Tektronix®
 COMMITTED TO EXCELLENCE

Wizards Workshop

October 3, 1980
 Issue 10-20

PRESENT WIRING SCHEME

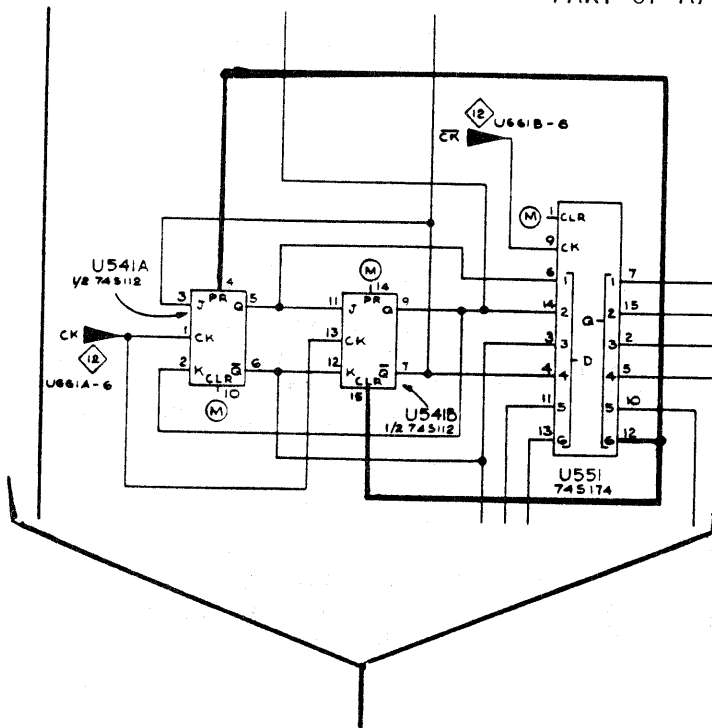
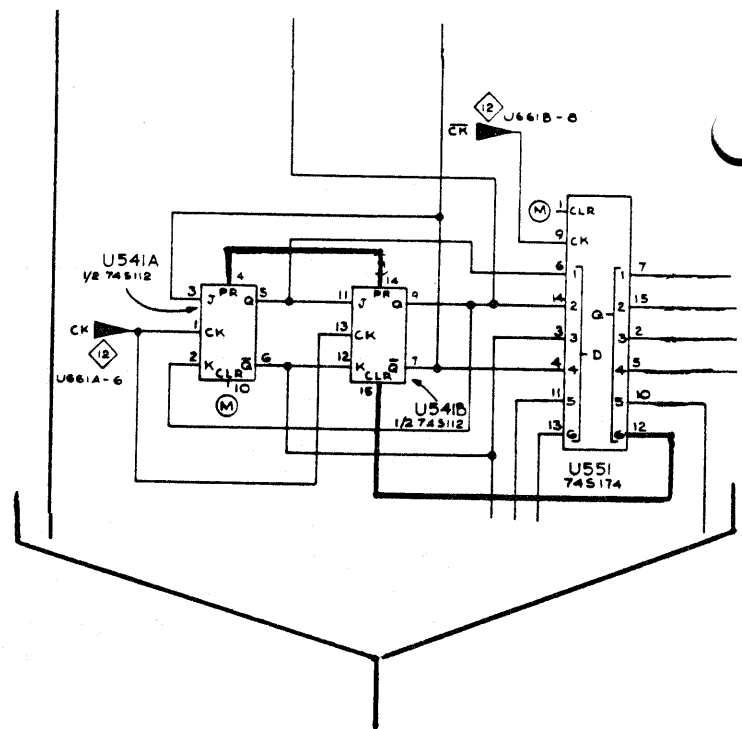
If A7U541 is not properly cleared the phase relationship between SUBCARRIER OUT and FULL FIELD OUT burst may be random. This failure can occur only in the non-gen locked mode. The solution is to remove the wire strap on the bottom of the A7 board that runs from A7U541 Pin 4 to A7U541 Pin 15 at Pin 15 and reconnect it to A7U541 Pin 14. Check that there is still a strap from A7U551 Pin 12 to A7U541 Pin 15. All units in the affected serial number range should have this change made as they come in for service. The changes to be made are outlined in the following drawings.

WIRING AFTER REQUIRED CHANGE

Figure 1: VR147 has been changed to improve brightness stability.

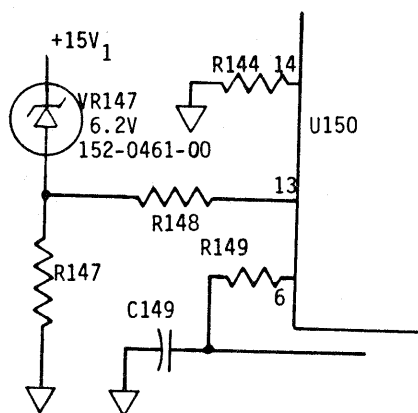
The two interface circuit boards share some changes. On both boards, VR147 is replaced by a zener diode with better thermal characteristics. This improves display intensity stability when temperature changes (see figure 1). Both boards also have metal oxide varistors RV72, RV73 and RV92 added to limit power supply fluctuations in the event of a high voltage arc (see figure 2). Varistor RV92 is connected between pins 1 and 3 of J500. Varistors RV72 and RV73 are soldered in parallel across C72 and C73 respectively.

Figure 3: Location of C193 pads on A6 video board.

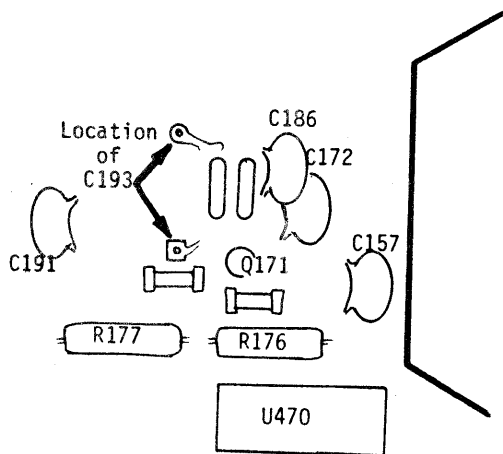
The standard interface, A6, also has C193 added to the video output amplifier. This reduces the 45 kHz component in the -100 volt power supply. Pads and runs for the inclusion of C193 already exist on the A6 layout next to R188. Their location is shown in figure 3.

Figure 5: Rerouting of C320 and addition of C307 to yoke driver boards.

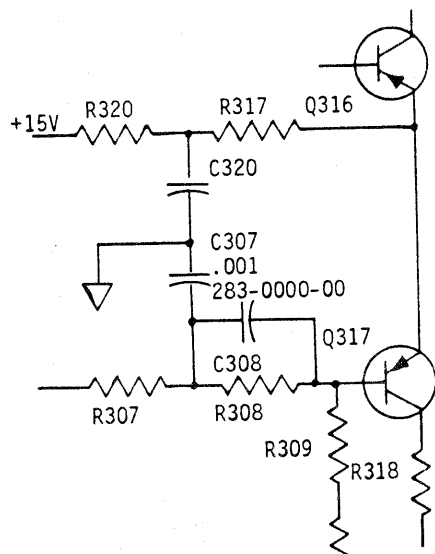
The ripple in the vertical driver has been reduced by adding capacitor C307 to the base circuit of Q317 and by rerouting one lead of C320. One lead of C307 is soldered to the node at R307, R308 and C308. The grounded lead of C320 is then lifted from its "dirty" ground and soldered to the unattached lead of C307. This remaining long lead is then dressed with sleeving and soldered to the "clean" ground at the anode of CR322 (see figure 5). Please note that mention of rerouting C320 was inadvertently omitted from the 045-0015-00 kit instructions.

Figure 6: CR394 added to retrace blanking circuit.

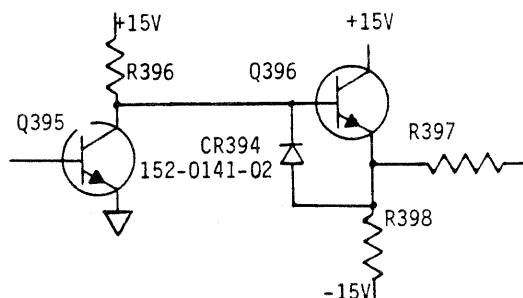
To prevent damage to Q396 in the retrace blanking circuitry, CR394 is added to the back of the boards between the base and emitter of Q396 (see figure 6).

Figure 7: R435, CR435, VR437 & VR454 affected on high voltage board.

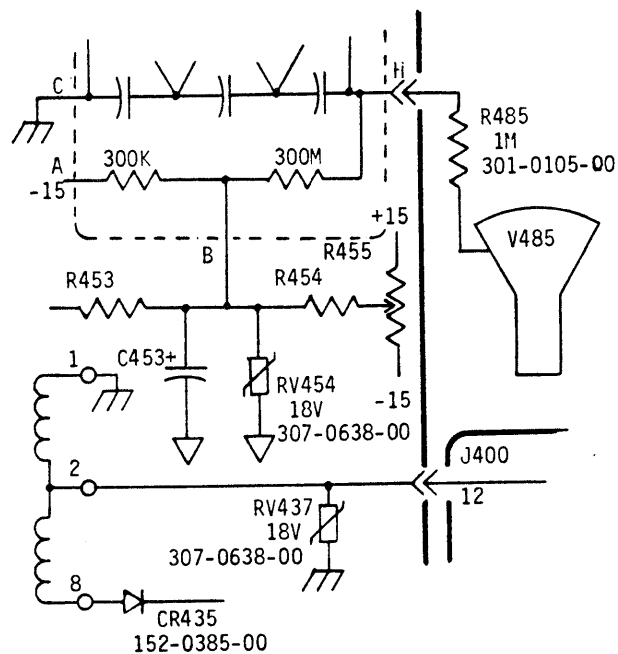
Metal oxide varistors RV437 and RV454 are added to the back of the boards as well. They limit voltage spikes caused by arcing (see figure 7).

Figure 9: Repositioning of C406 & C407

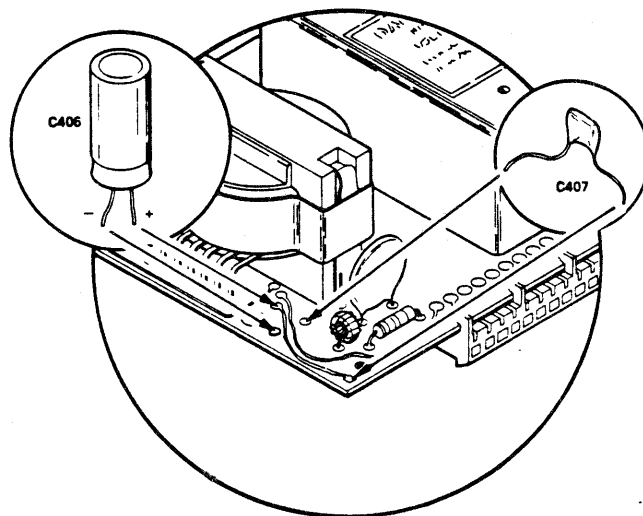
The value of C406 is increased for better decoupling of the +20 volt supply line and to better withstand the high surge current. However, the large size of C406 requires that the positioning of C406 & C407 be changed as shown in figure 9. The correct value for C406 is 180 μ f @ 40V. Please note this correction to the 045-0015-00 kit instructions.

Figure 10: Installing R485 into the CRT anode lead

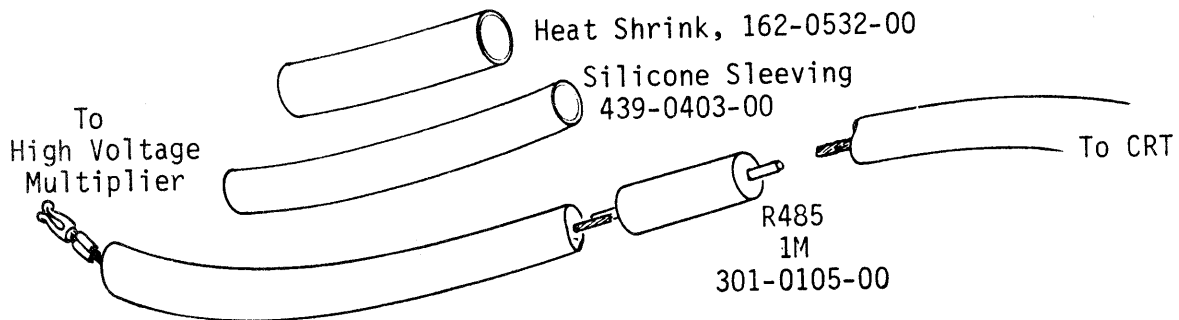
A one megohm resistor, R485, has been spliced into the CRT anode lead to reduce noise in the raster display. This portion of modification #37777 is not included in field kit 045-0015-00. It can, however, be installed in instruments where high voltage noise appears to be a problem.

First, the CRT anode lead is cut three and one half inches from the end that plugs into the high voltage multiplier, then the cut ends are stripped of $\frac{1}{4}$ " of insulation. Next, the one megohm resistor (P/N 301-0105-00) is soldered onto the free wire (the part that attaches to the high voltage multiplier). A dab of silicone rubber sealant (P/N 006-1171-00) is put around the solder joint to prevent contamination or leakage. Now, a three inch section of silicone sleeving is dressed over the resistor and lead leaving the unsoldered end of the resistor protruding beyond the sleeving. This end of R485 is then soldered to the remaining part of the CRT anode lead. Another dab of silicone rubber sealant is applied and the sleeving is centered over the resistor. Finally, a two inch piece of heat shrink tubing (P/N 162-0532-00) is centered over the sleeve and shrunk into place to prevent the sleeve from sliding off.

Figure 1: VR147 has been changed to improve brightness stability.

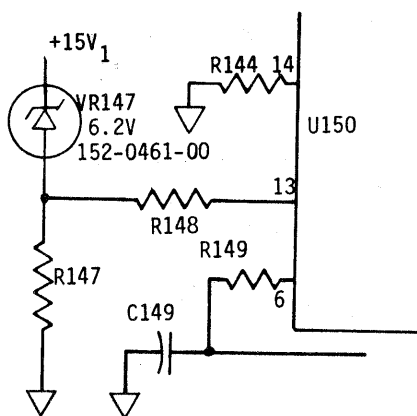
The two interface circuit boards share some changes. On both boards, VR147 is replaced by a zener diode with better thermal characteristics. This improves display intensity stability when temperature changes (see figure 1). Both boards also have metal oxide varistors RV72, RV73 and RV92 added to limit power supply fluctuations in the event of a high voltage arc (see figure 2). Varistor RV92 is connected between pins 1 and 3 of J500. Varistors RV72 and RV73 are soldered in parallel across C72 and C73 respectively.

Figure 3: Location of C193 pads on A6 video board.

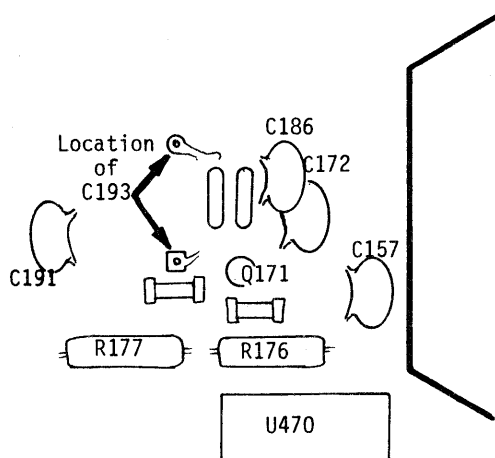
The standard interface, A6, also has C193 added to the video output amplifier. This reduces the 45 kHz component in the -100 volt power supply. Pads and runs for the inclusion of C193 already exist on the A6 layout next to R188. Their location is shown in figure 3.

Figure 5: Rerouting of C320 and addition of C307 to yoke driver boards.

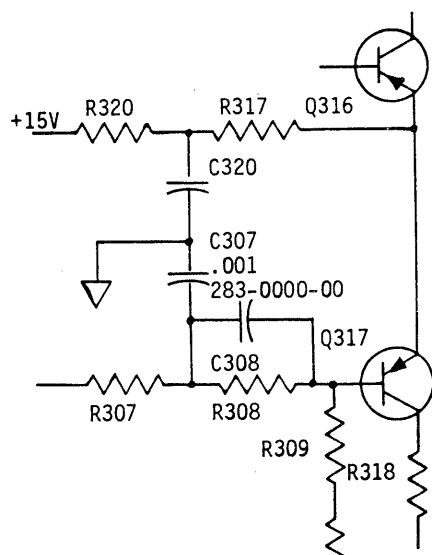
The ripple in the vertical driver has been reduced by adding capacitor C307 to the base circuit of Q317 and by rerouting one lead of C320. One lead of C307 is soldered to the node at R307, R308 and C308. The grounded lead of C320 is then lifted from its "dirty" ground and soldered to the unattached lead of C307. This remaining long lead is then dressed with sleeving and soldered to the "clean" ground at the anode of CR322 (see figure 5). Please note that mention of rerouting C320 was inadvertently omitted from the 045-0015-00 kit instructions.

Figure 6: CR394 added to retrace blanking circuit.

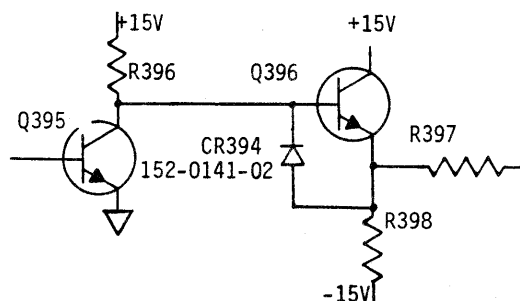
To prevent damage to Q396 in the retrace blanking circuitry, CR394 is added to the back of the boards between the base and emitter of Q396 (see figure 6).

Figure 7: R435, CR435, VR437 & VR454 affected on high voltage board.

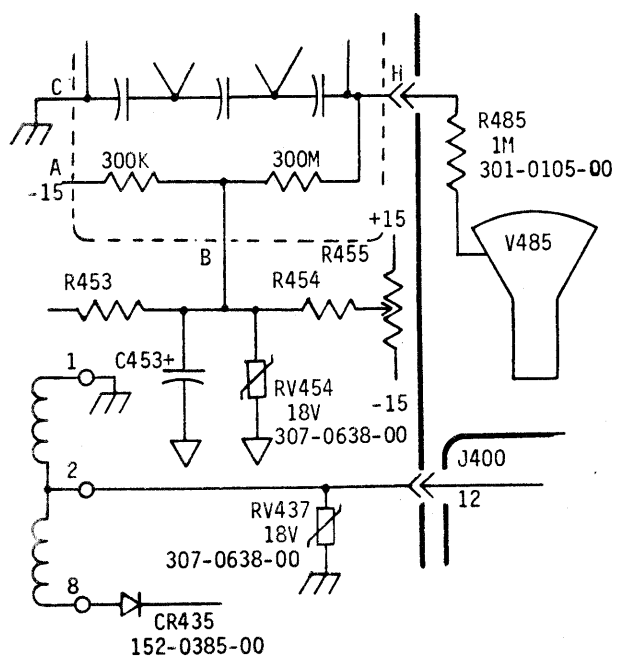
Metal oxide varistors RV437 and RV454 are added to the back of the boards as well. They limit voltage spikes caused by arcing (see figure 7).

Figure 9: Repositioning of C406 & C407

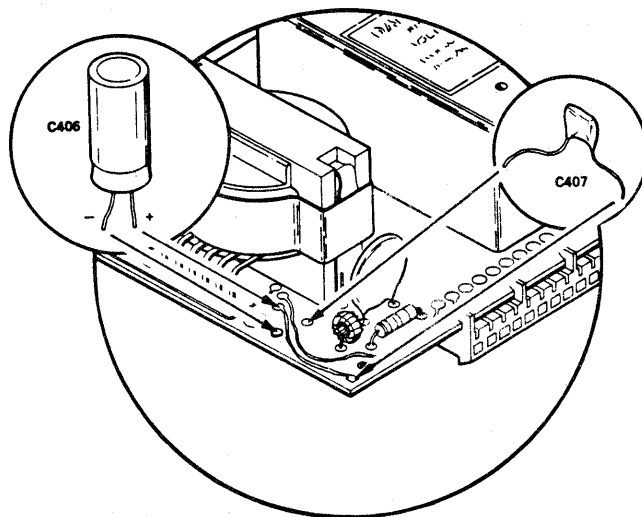
The value of C406 is increased for better decoupling of the +20 volt supply line and to better withstand the high surge current. However, the large size of C406 requires that the positioning of C406 & C407 be changed as shown in figure 9. The correct value for C406 is 180 μ f @ 40V. Please note this correction to the 045-0015-00 kit instructions.

Figure 10: Installing R485 into the CRT anode lead

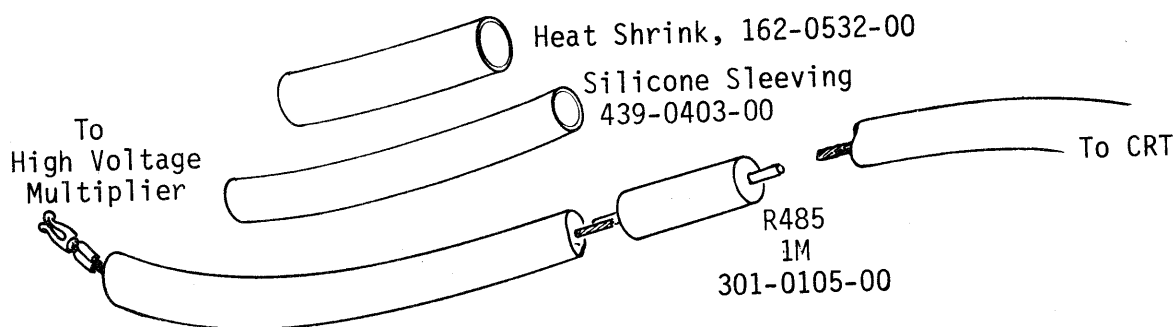
A one megohm resistor, R485, has been spliced into the CRT anode lead to reduce noise in the raster display. This portion of modification #37777 is not included in field kit 045-0015-00. It can, however, be installed in instruments where high voltage noise appears to be a problem.

First, the CRT anode lead is cut three and one half inches from the end that plugs into the high voltage multiplier, then the cut ends are stripped of $\frac{1}{4}$ " of insulation. Next, the one megohm resistor (P/N 301-0105-00) is soldered onto the free wire (the part that attaches to the high voltage multiplier). A dab of silicone rubber sealant (P/N 006-1171-00) is put around the solder joint to prevent contamination or leakage. Now, a three inch section of silicone sleeving is dressed over the resistor and lead leaving the unsoldered end of the resistor protruding beyond the sleeving. This end of R485 is then soldered to the remaining part of the CRT anode lead. Another dab of silicone rubber sealant is applied and the sleeving is centered over the resistor. Finally, a two inch piece of heat shrink tubing (P/N 162-0532-00) is centered over the sleeve and shrunk into place to prevent the sleeve from sliding off.

Figure 2 #M38624; Schematic 9-2 4054 Service Manual
Deflection Amp; SLU Sensor Circuitry

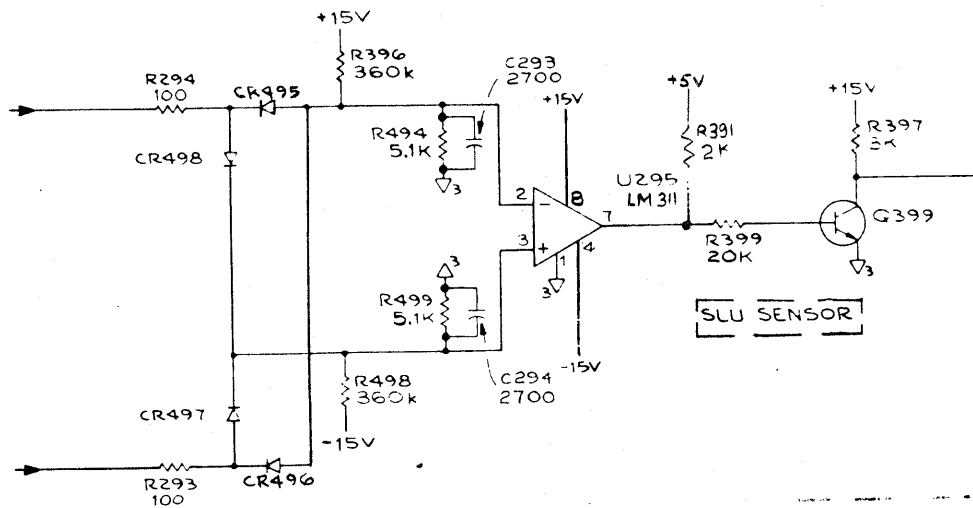
Modification #M39710 has been superseded and replaced by modification #M38624. Change #M38624 addresses both the -02 and -03 level Deflection Amp for both the 618 and 4054. This change is being implemented in both the 618 and the 4054 Deflection Amp and rolls both the -02 and -03 level boards to a -04 level board. There is a kit available which includes the instructions for the implementation of #M38624 and the kit number is 040-0977-00. In addition to correcting the refresh graphics break-up this new modification solves the insufficient resolution of the hard copy gain trim due to extreme range of the variable resistors. (Figure 2)

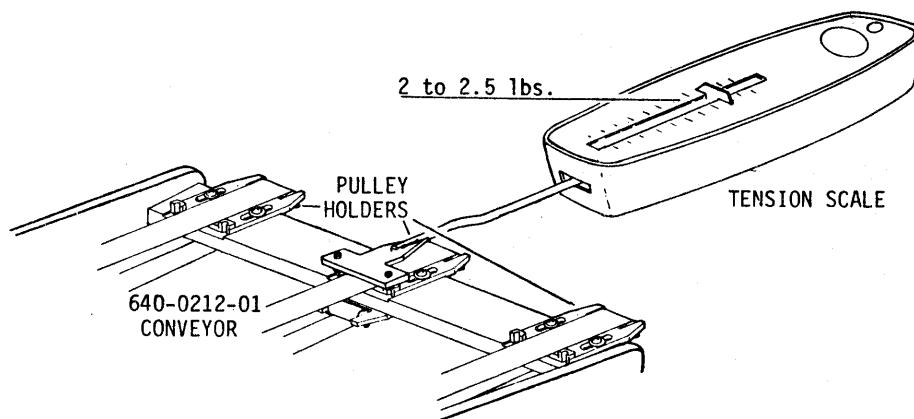
The 640-0212-00 conveyor assembly used in the 4633A and the 4634 has been prone to early belt failure and paper jamming.

To correct these problems, mod 37411 replaces the old conveyor with the 640-0212-01 assembly. This new conveyor uses more durable belts and allows for belt tension adjustments.

The -00 conveyor will no longer be supported. In the event of a failure, replace the entire -00 conveyor with the new -01 assembly.

067-0919-99 BLANK PROGRAM MODULE

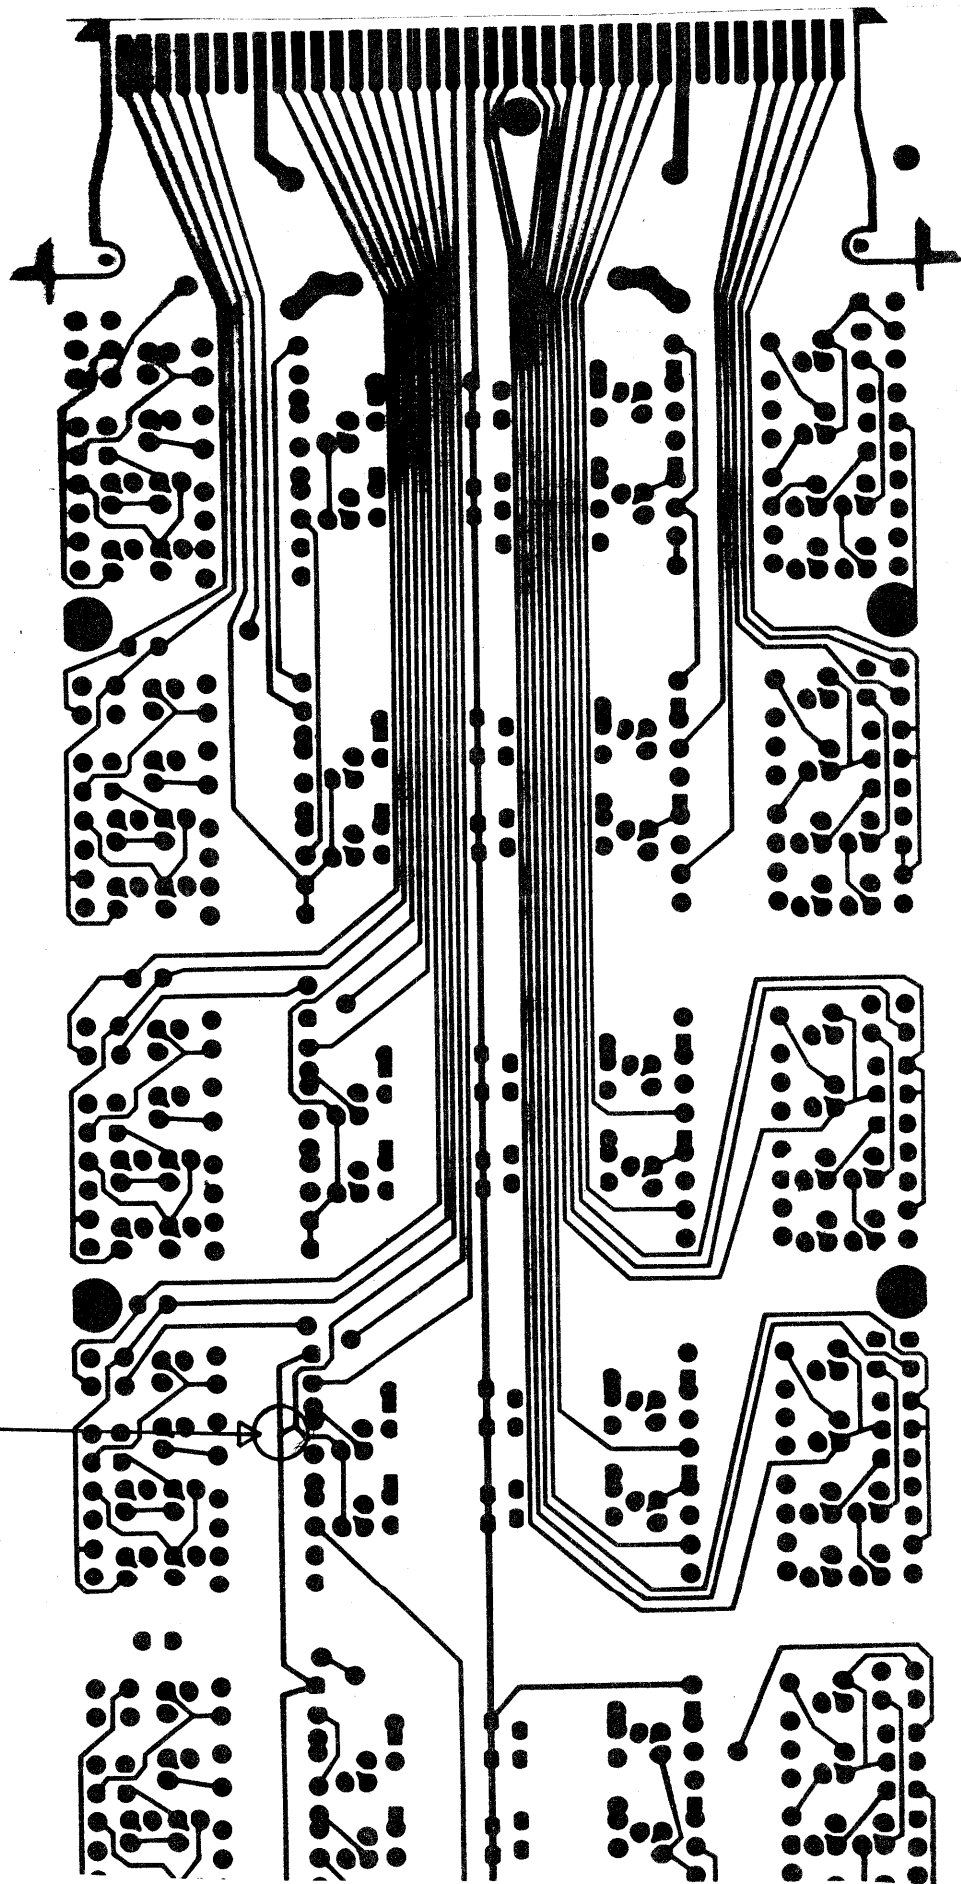
Some unprogrammed modules have been shipped which have a serious wiring error. This error may destroy channel 10 and the power source connected to channel 10. Inspect any 067-0919-99 Plug-ins in your area. Look for the board number. If it is PA6544-03 find the channel 10 area on the back of the board. Look for the run as shown in the diagram. Cut and remove the 2.5 mm error. The error was caused by a tape scrap.

ROM straps to select the appropriate ROM's

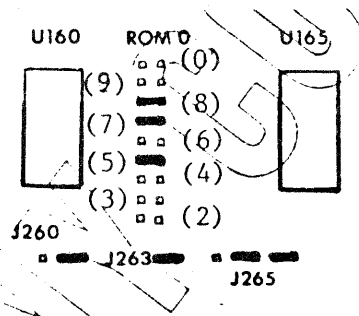
NOTE: ROM numbers are in parentheses. The straps, as shown, select ROMs 5, 7, & 8. These are the ROMs used in V-3 & 4 F/W.
